ADDENDUM NO. [2]

Date: September 17, 2019

**RE: SCHOOL DISTRICT OF LA CROSSE
7 RIVERS CHARTER SCHOOL
225 5TH AVE SOUTH
LA CROSSE, WI 54601
HSR 19003**

4 SOUTH ELEVATION
1/8" = 1'-0"

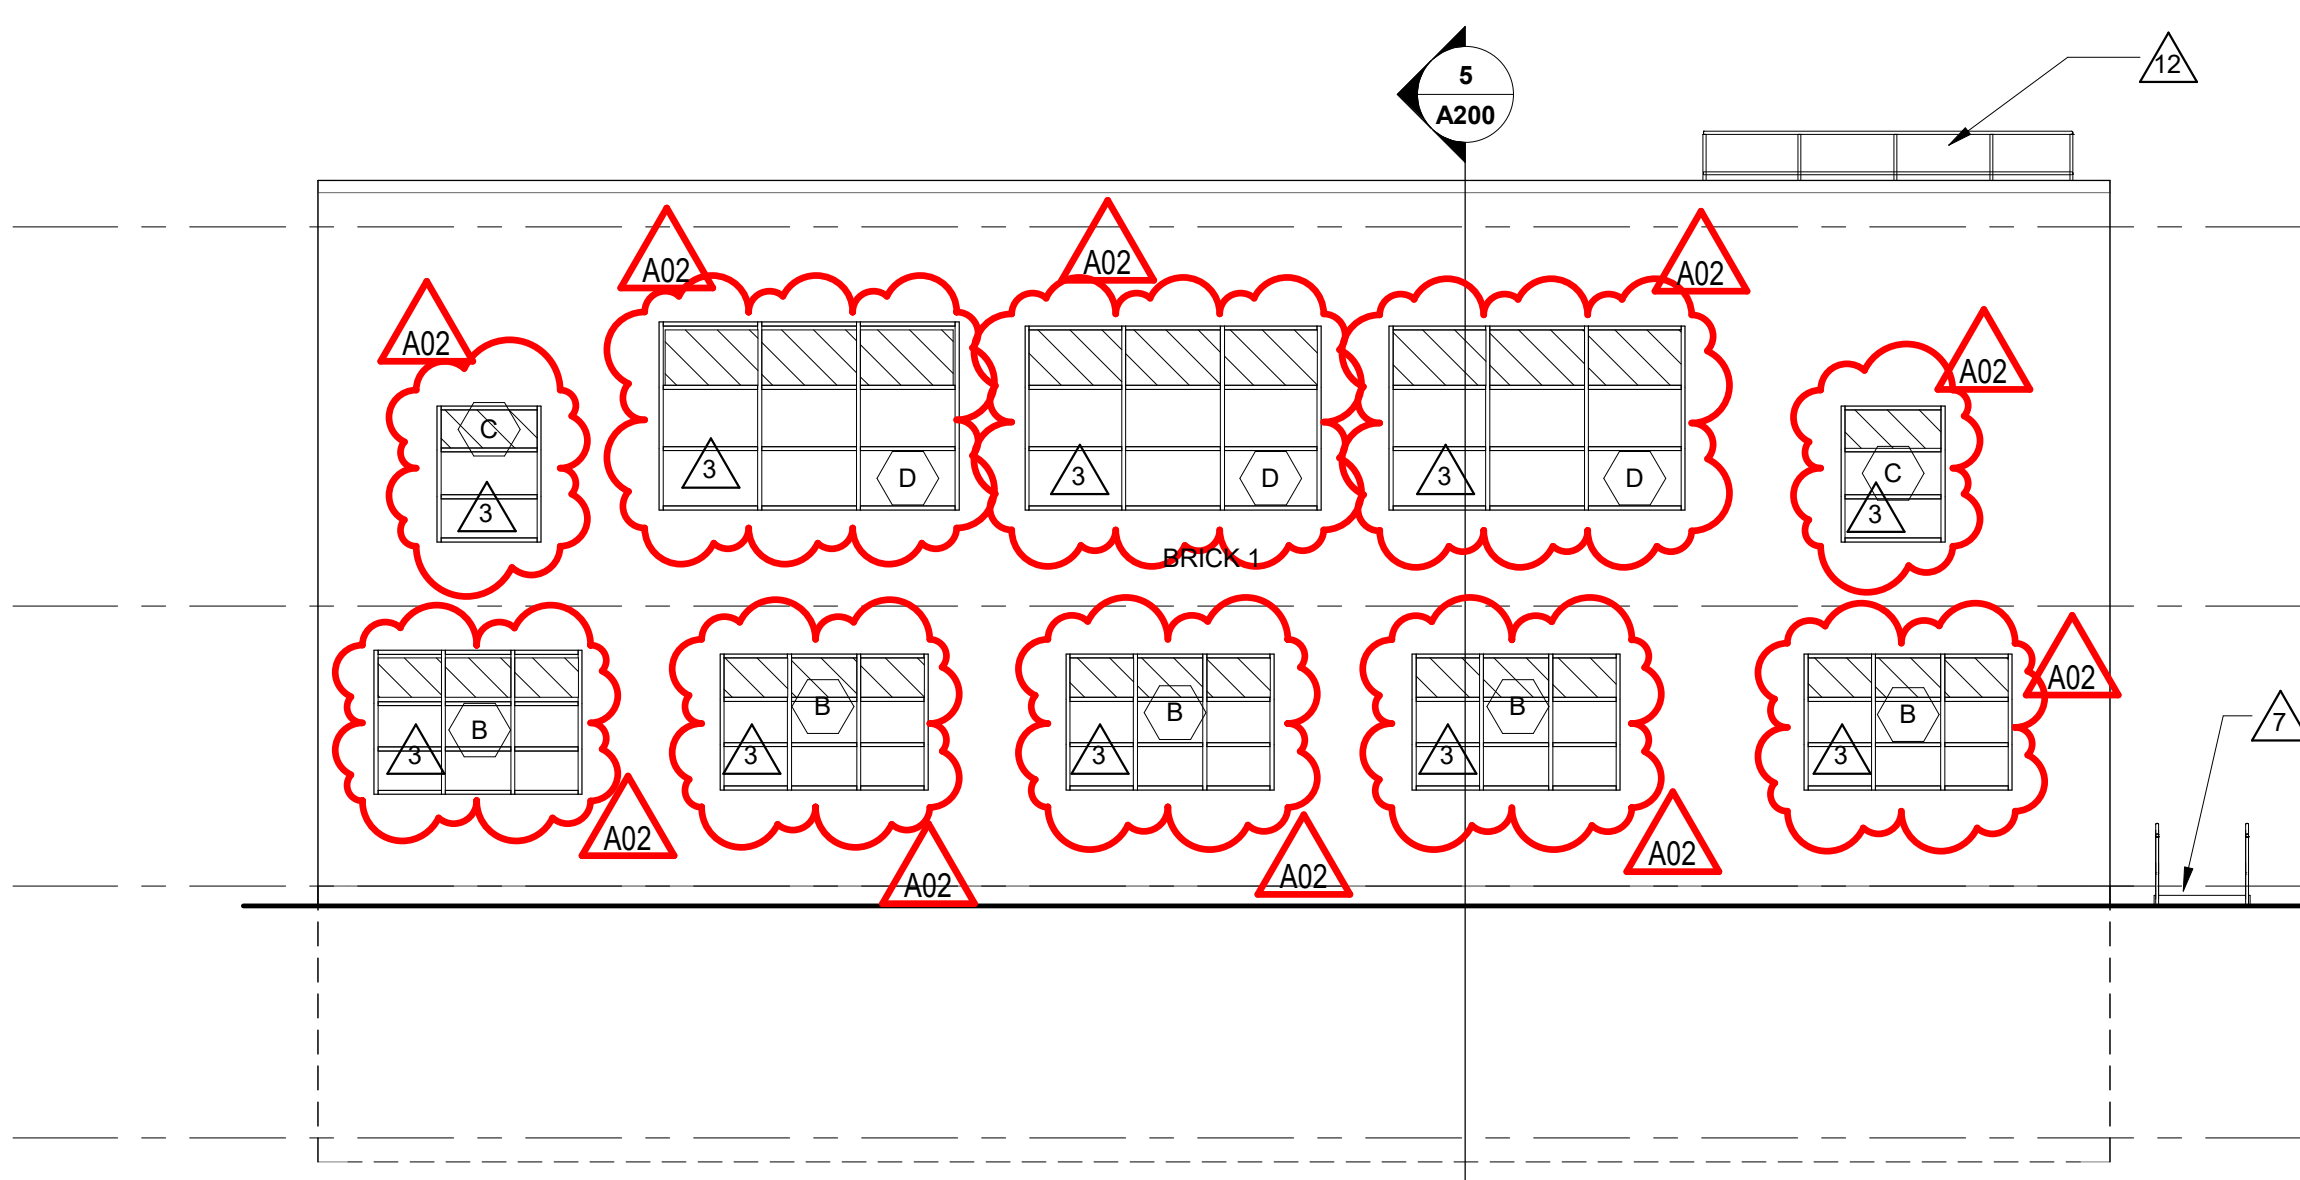
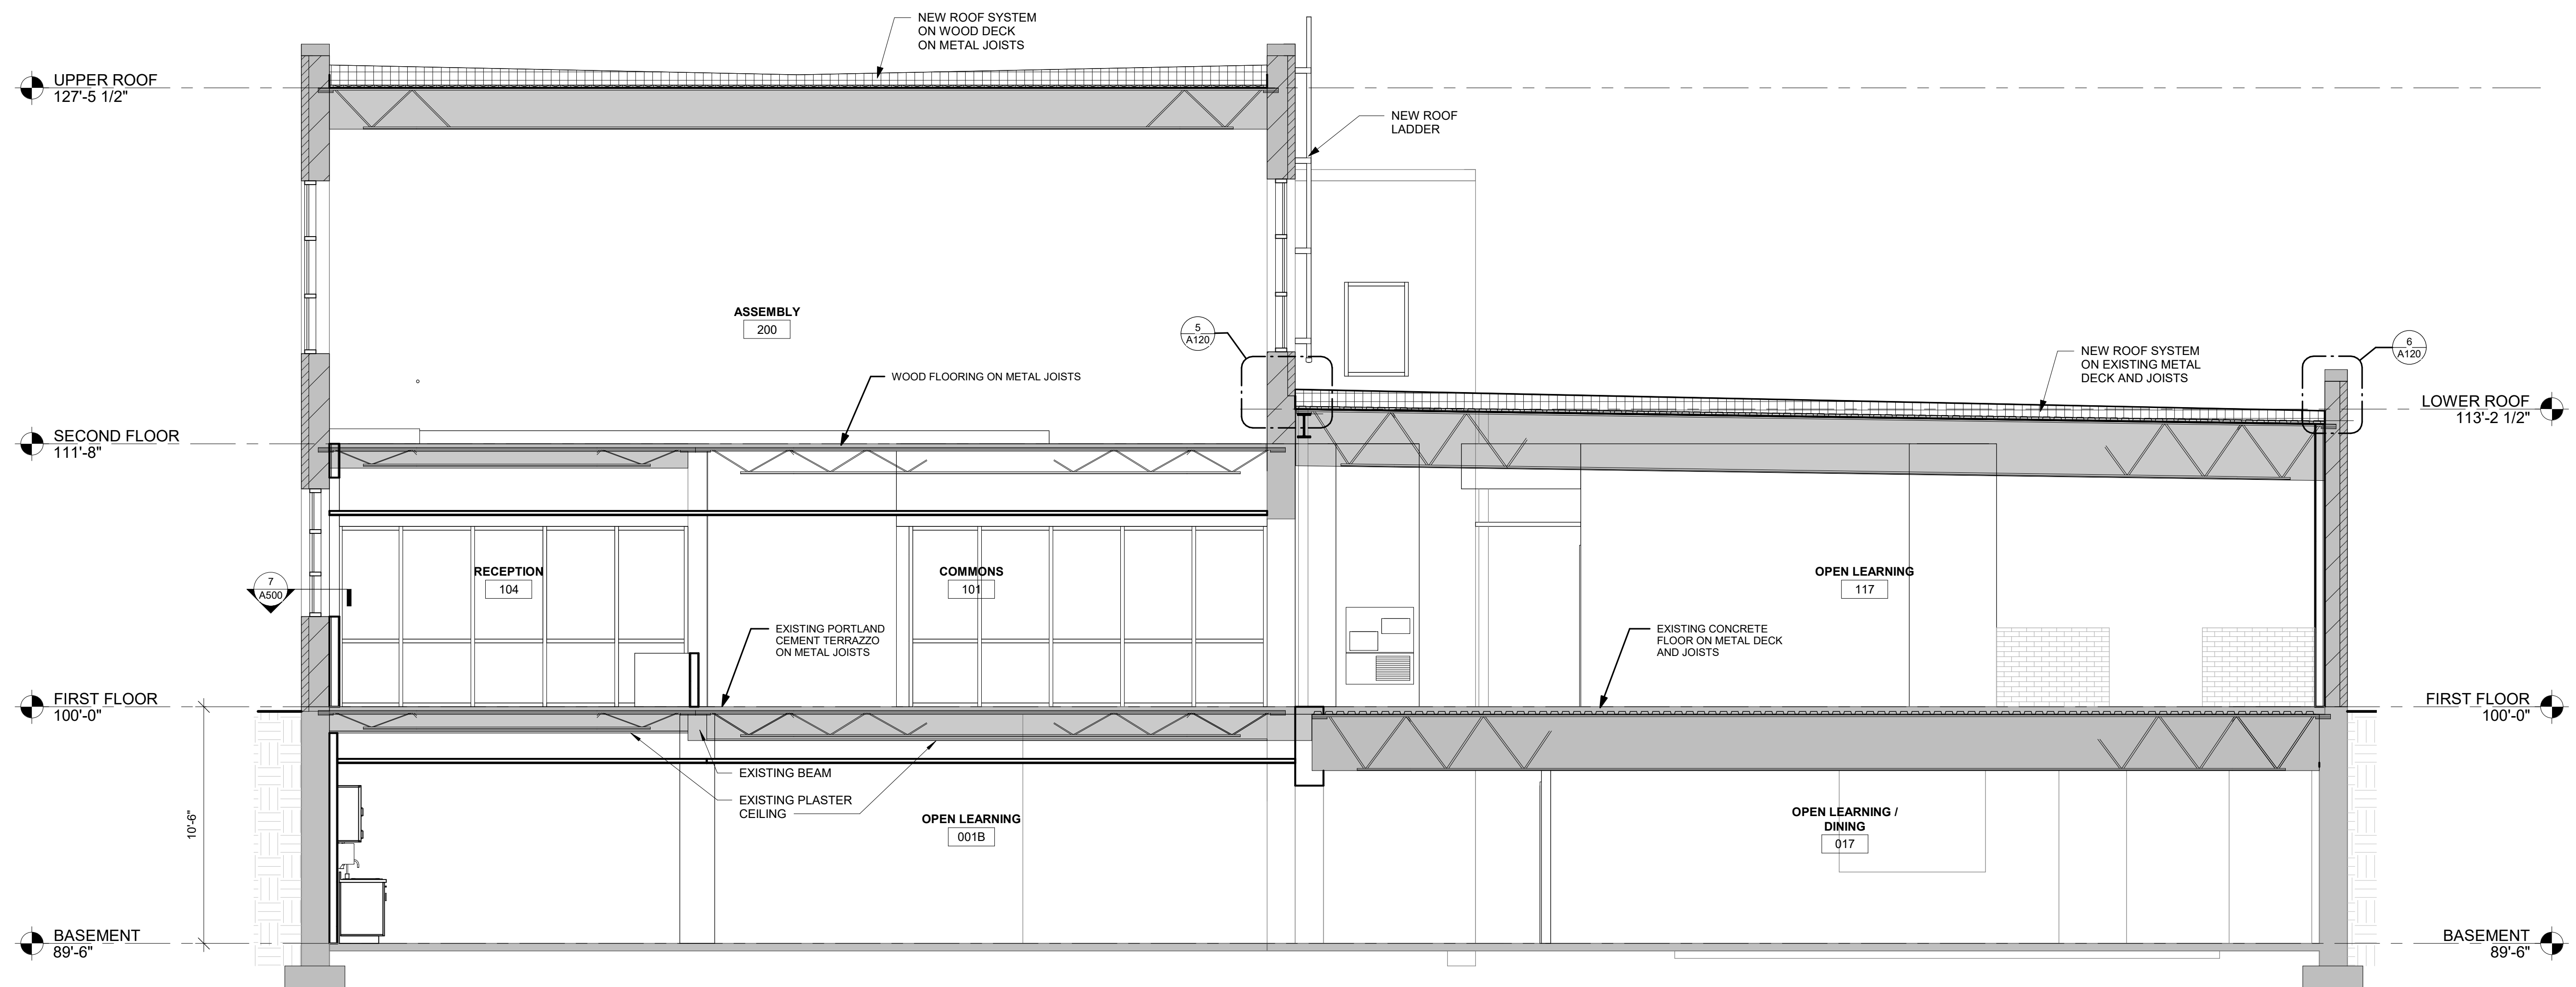
- a. Revisions clouded on Drawing.
- b. New windows shown.

15. Sheet A201 INTERIOR ELEVATIONS 30 x 42 attached hereto

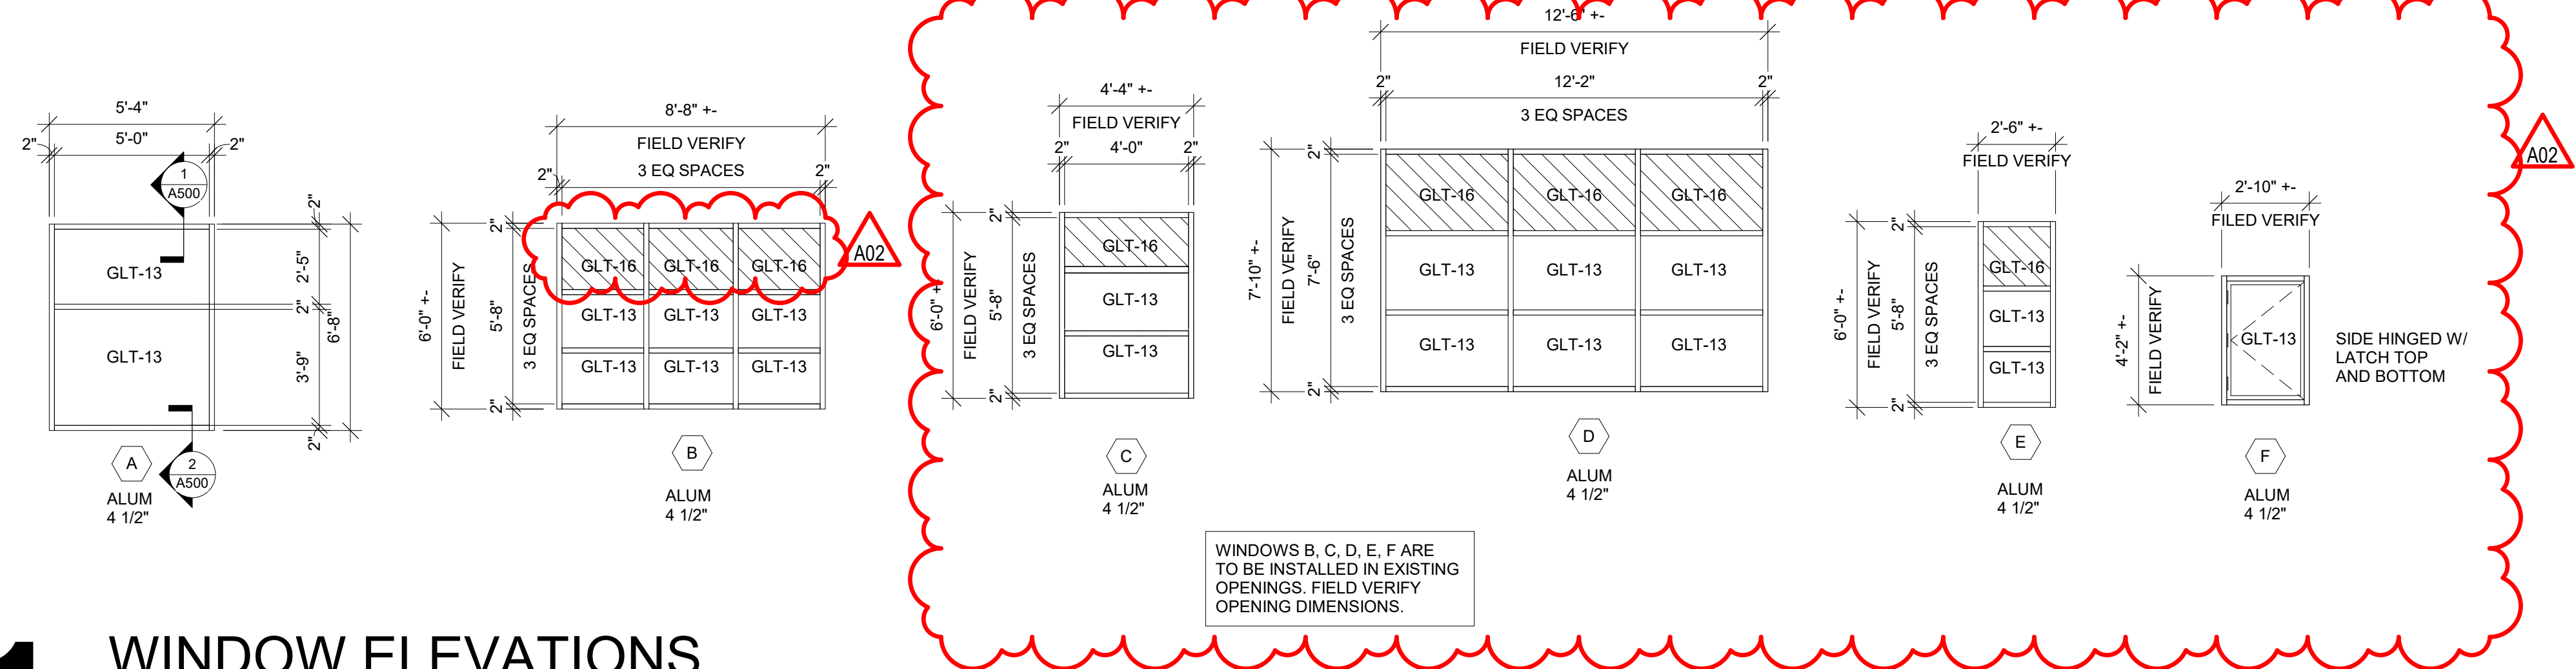
- a. Revisions clouded on Drawing.
- b. Added window elevations C through F.

- a. Revisions clouded on Drawing.
21. Sheet P102 FIRST FLOOR REMODEL PLAN 30 x 42 attached hereto
 - a. Revisions clouded on Drawing.
22. Sheet P103 SECOND FLOOR REMODEL PLAN 30 x 42 attached hereto

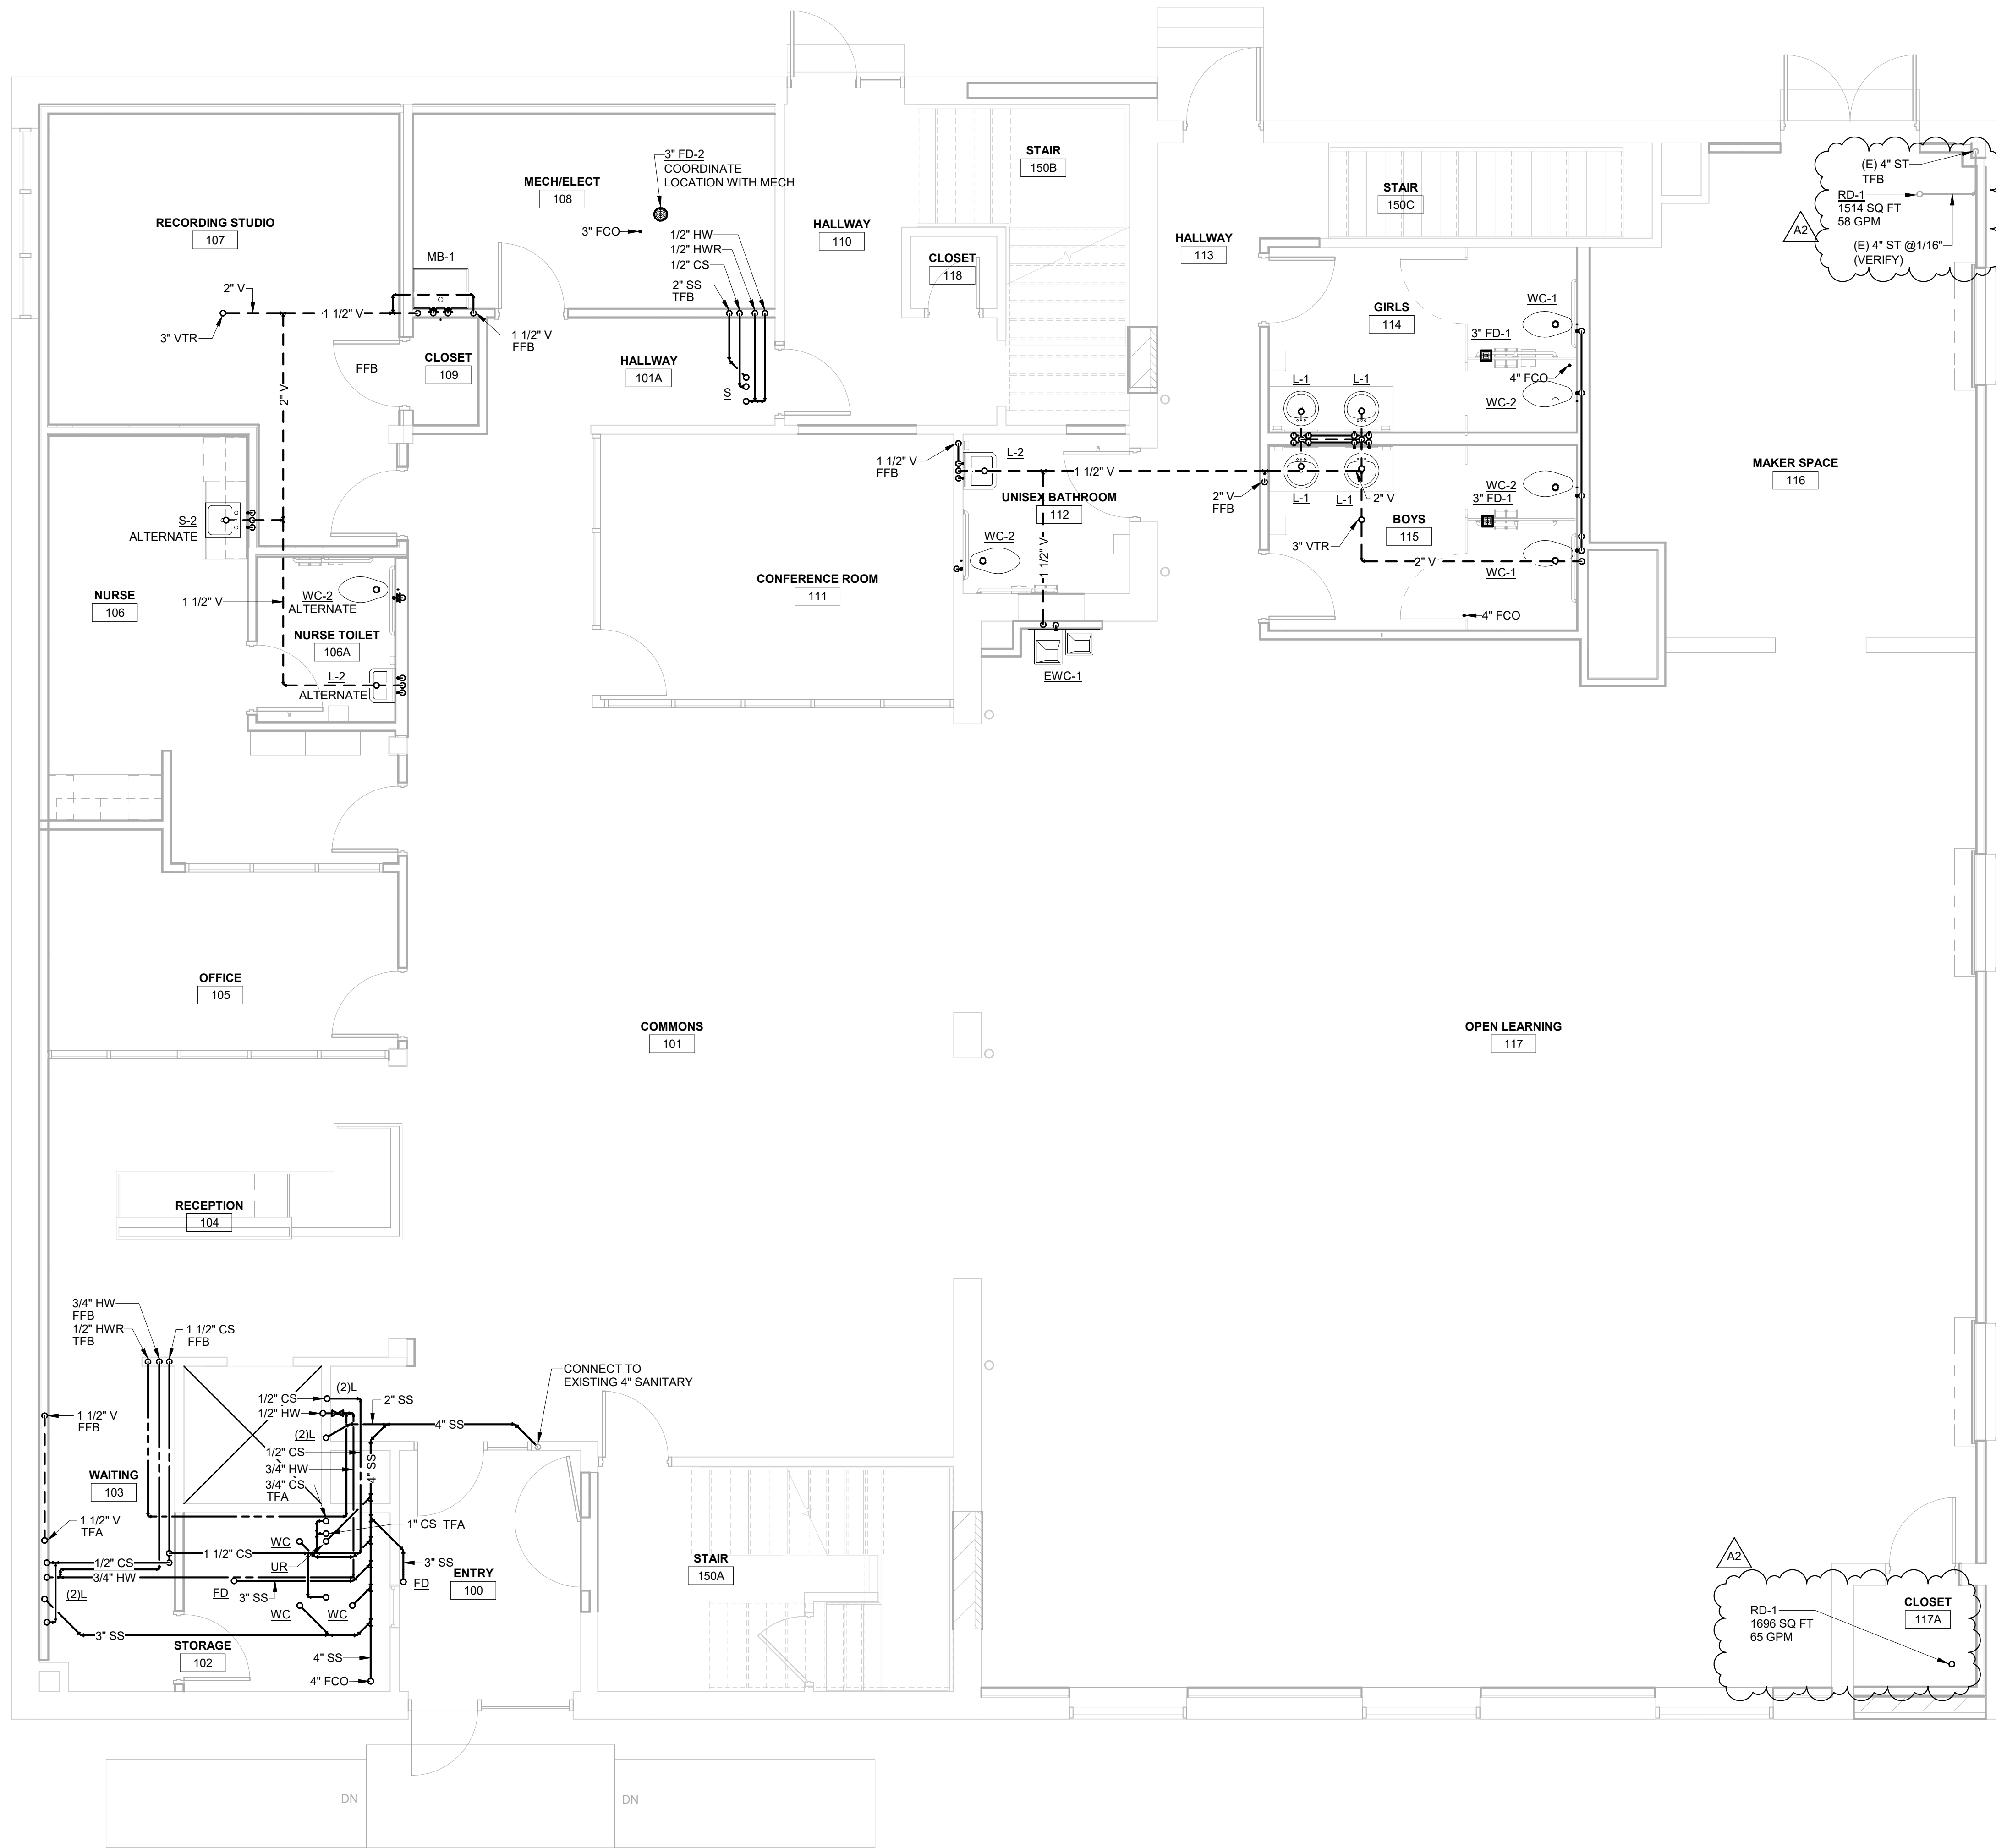
- a. Revisions clouded on Drawing.
 - b. Gas piping, new roof drain and storm piping revisions.
23. Sheet P200 ISOMETRIC DIAGRAMS 30 x 42 attached hereto
